V2500-A1 PROPULSION SYSTEMS SERVICE BULLETIN

This document transmits the Initial Issue of Service Bulletin EV2500-70-0808

INFORMATION – ENGINE – LP COMPRESSOR – INTRODUCTION OF A NEW ANNULUS FILLER WITH
REDESIGNED SOURCE MATERIAL

Family Tree - Annulus Filler (72-31-11, Fig 01, Item 100)
Figure 1

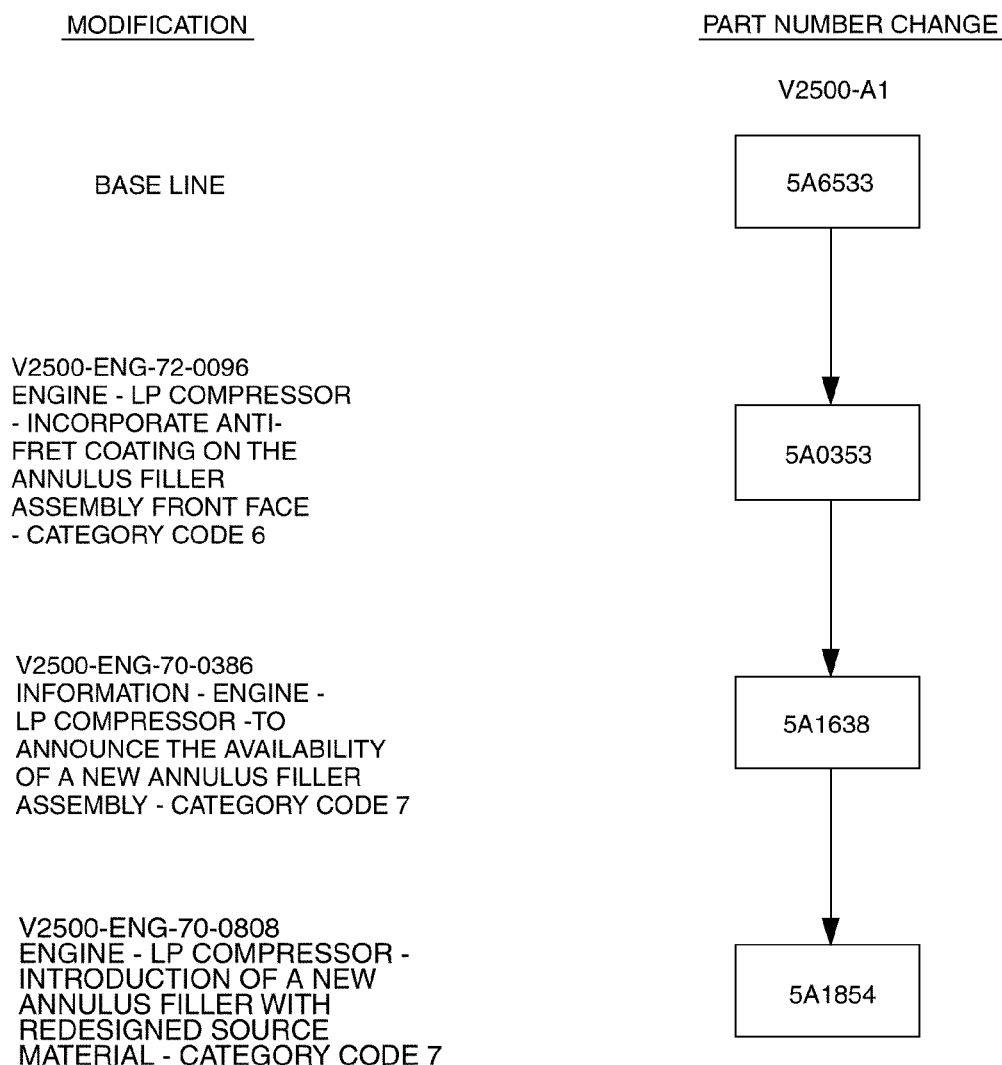
(a) The profile of the Annulus Filler is changed to minimize machining during the manufacturing process.

(2) For relationship with other Service Bulletins, see Fig. 1 'Family Tree'.

(3) Existing part can not be reworked to a new part.

FIG ITEM NO.	NEW PART NO.	QTY	PART TITLE	MAT	OLD PART NO.	INSTR DISP
01100	5A1854	22	Filler Annulus	-	5A1638	(A)(B)(S1)

(S1) Old and new part is freely and fully interchangeable both physically and functionally.
